Analysis and Report on Sections 2 and 3 of the Comments of the Keweenaw Bay Indian Community (KBIC)—Final

Prepared for the United States Environmental Protection Agency – Region 5

By The Cadmus Group, Inc. under contract # EP-C-08-015

March 2010

Figure 3. Bedrock faults, dike, and lineaments, and modeled FEFLOW fractures.

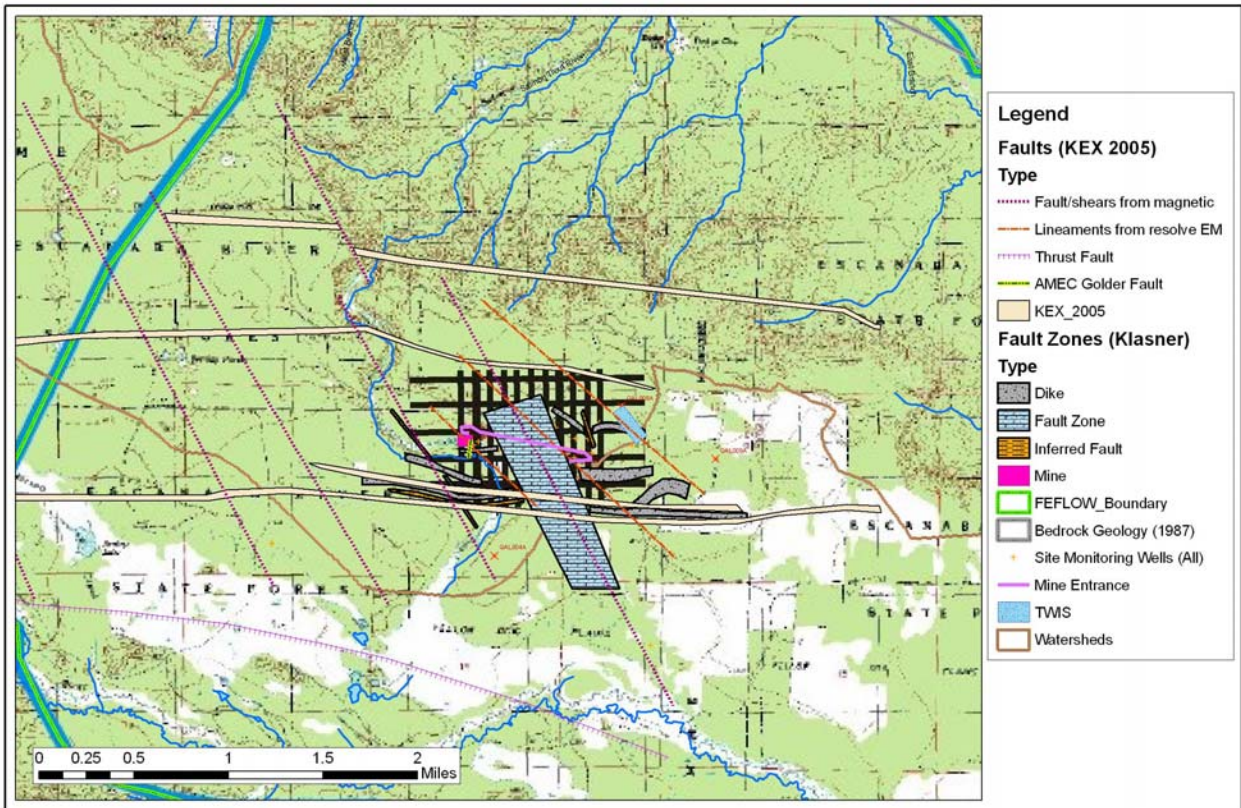
In Figure 3, a closer examination is presented, and the modeled vertical fractures included in the FEFLOW model are superimposed (Figure 5-3, Golder Associates, 2006b).

KEMC did include vertical fractures, but only in the lower bedrock. It is unclear why the fractures were not included in the upper bedrock. Cadmus finds that this assumption does not appear to be supported.¹⁶

Figure 4a. Bedrock faults, dike, and lineaments. The mapped area is within the FEFLOW model area.

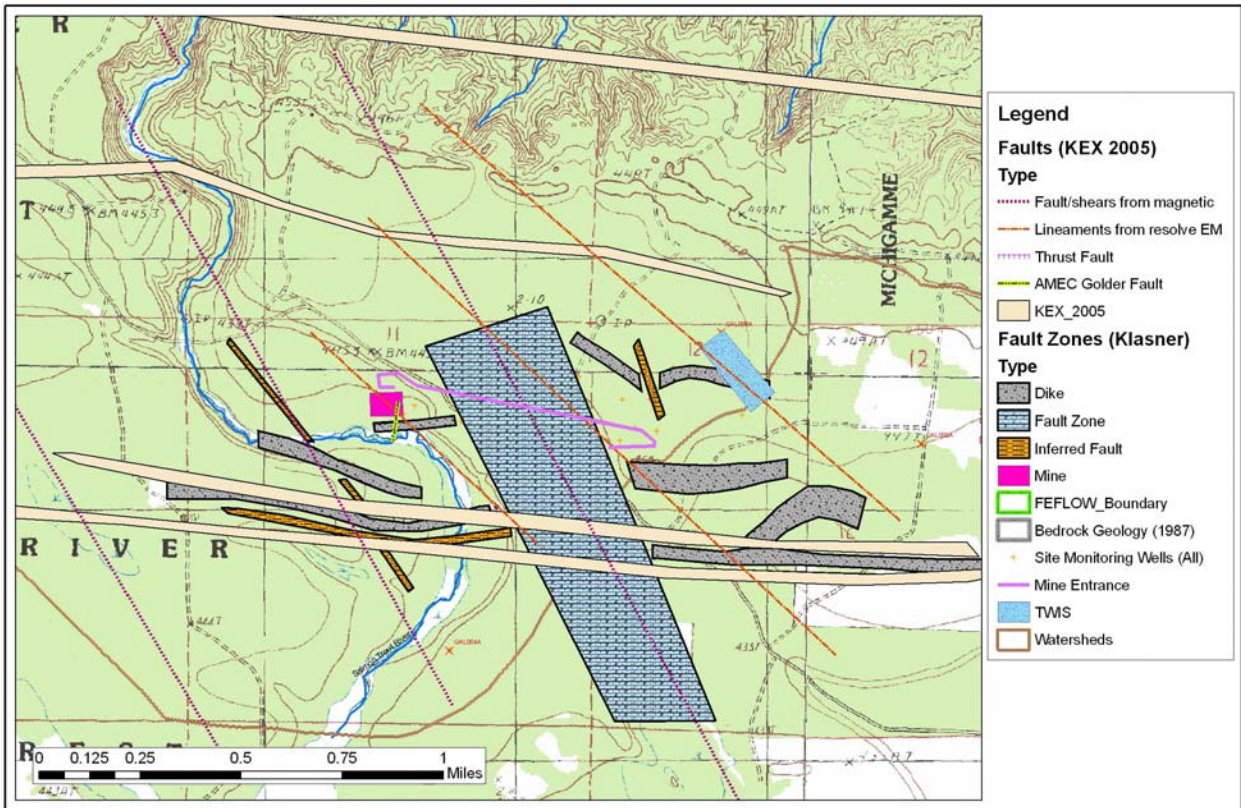
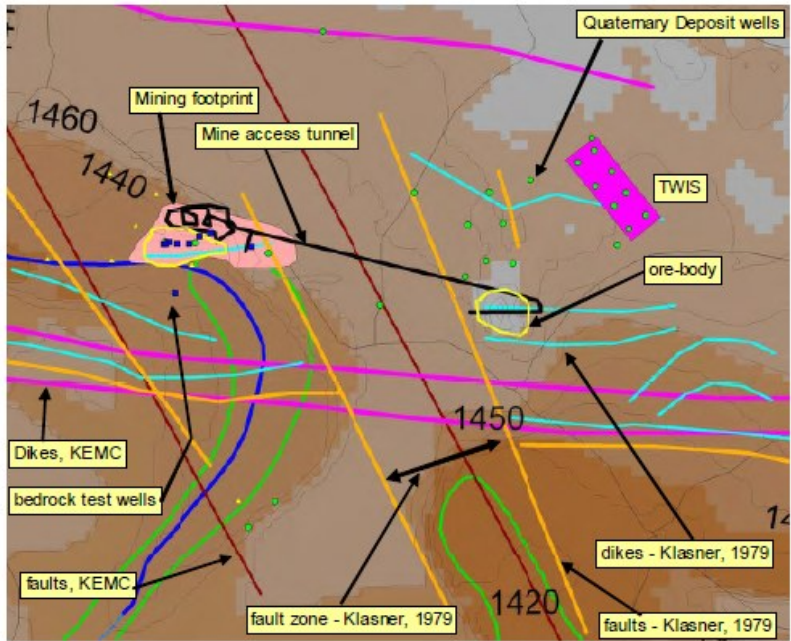
The region about 2 miles across the faults shown in Figure 4a is similar to that presented by KBIC (2009) (KBIC's Figure 2-1; Figure 4b below).

Figure 6. Site geology, and hydraulic heads predicted for when mining has ceased, using revised base case (Golder Associates, 2006b, Figure 9.2). The mapped area is within the FEFLOW model area.

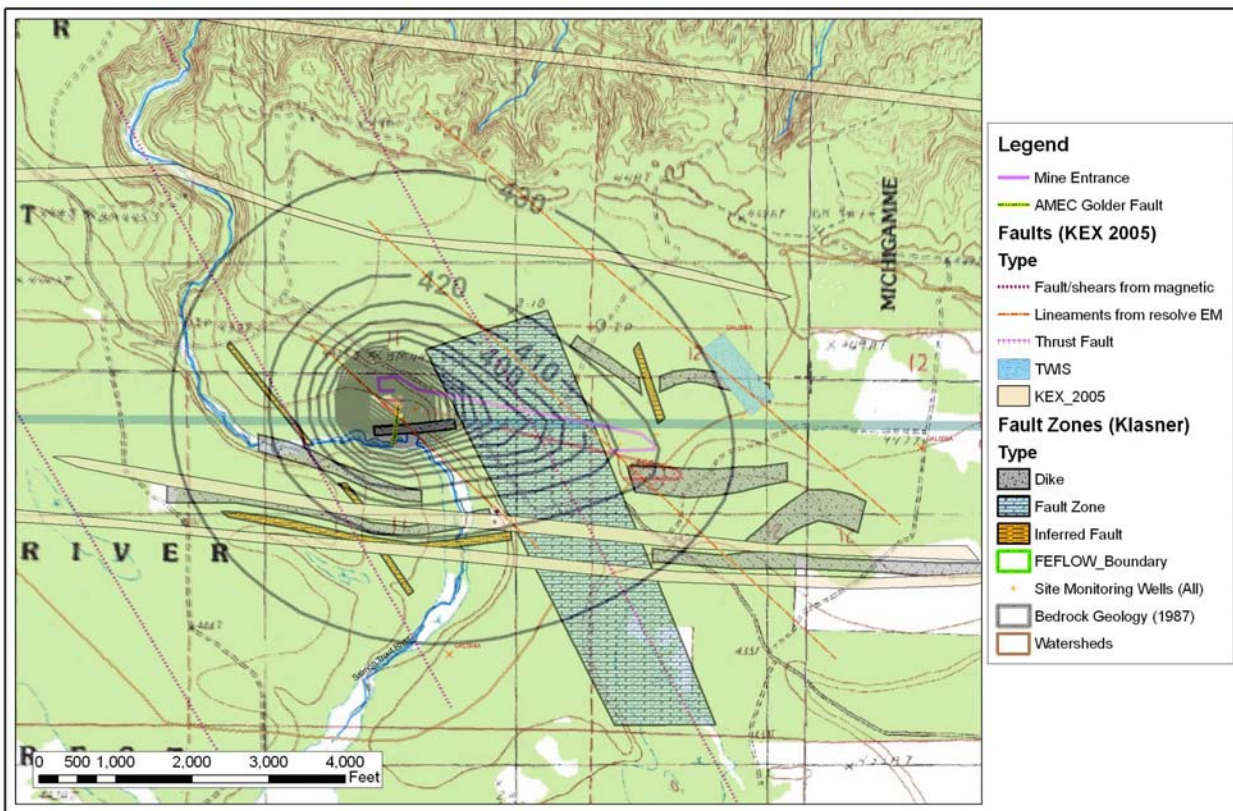
In Figure 6, the model predictions of hydraulic head (Golder Associates, 2006b, Figure 9-2) are shown. The modeled extent of the depressurization predictions is inconsistent with the presence of the fault, dikes, and lineaments. Dikes are typically very low permeability and one would not expect pressure changes to cross these features.¹⁴

The fault zone, dikes, and lineaments were essentially ignored in the characterization of the bedrock flow system used to develop the FEFLOW model.¹⁵ Cadmus finds that this is a major shortcoming in the ability of the model to accurately represent ground water flow patterns during

Figure 11. Predicted results for revised KBIC Scenario 6 (100x fault permeability). The mapped area is within the FEFLOW model area.

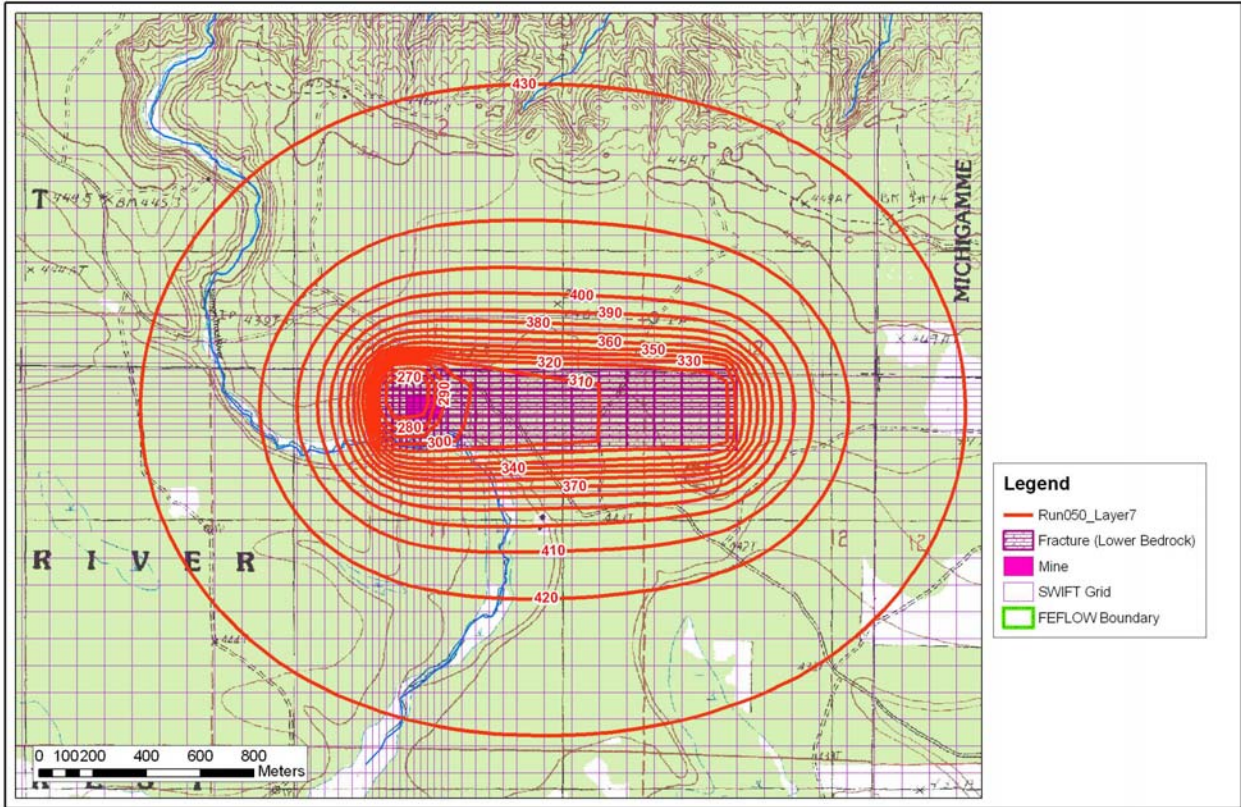
Because of uncertainty in the hydrogeologic characterization, it is reasonable to conduct simulations with variations in the fracture permeability. This is not the same as a true uncertainty analysis, but does provide insight regarding how the system responds to the unknown variability of localized fractures in the lower bedrock. A rigorous uncertainty analysis would provide quantitative statistics resulting from parameter uncertainty (Hill and Tiedeman, 2007). In Figure 11, the predicted hydraulic heads for KBIC Scenario 6, wherein the vertical conductivity is increased by a factor of 100, are shown. The more regular contours in Figure 11 are a reasonable result. Note that the extent of the depressurization increased slightly whereas the rate of mine inflow increased by a factor of over 50.

Figure 12. Predicted results including hypothesized no-flow dikes. The mapped area is within the FEFLOW model area.

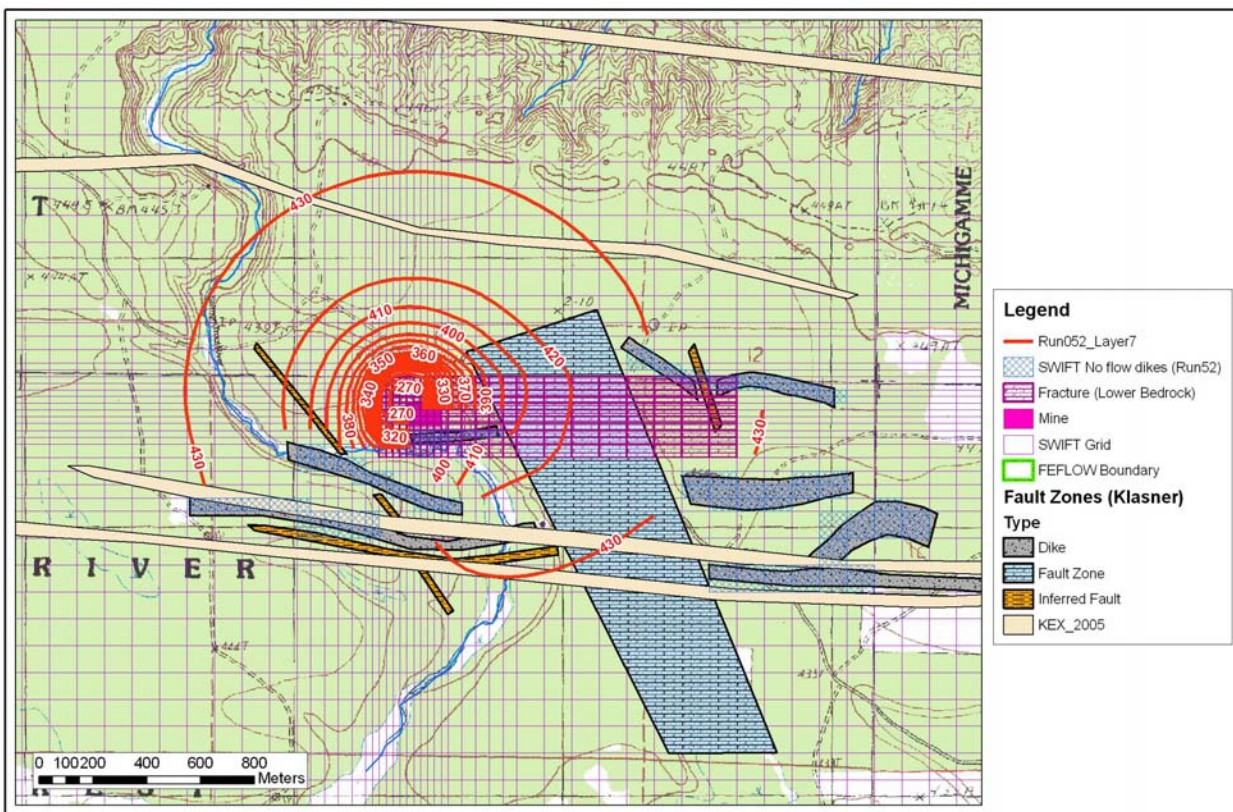
Given the uncertainty of the geologic characterization, an evaluation simulation (Run 52) was conducted in which the dikes as presented by Klasner et al. (1979) were included. For simplicity, the dikes were represented as no-flow cells that are completely impermeable. In Figure 12, the predicted equipotential lines are interrupted by the dikes. The contours are discontinuous because the no-flow cells representing the dikes in SWIFT are inactive cells. (Note that these inactive cells are represented as blue cross-hatched areas labeled "SWIFT No flow dikes (Run52)" in Figure 12.) The small gaps are due to the interpolation technique, in which contour lines are stopped prematurely within the active cells and cannot be extended to the inactive cells. Overall,

the extent of the depressurization is similar to the base case (Run 47), as shown in Figure 10. Thus, the absence of the dikes in KEMC's model is a reasonable simplification.²⁰
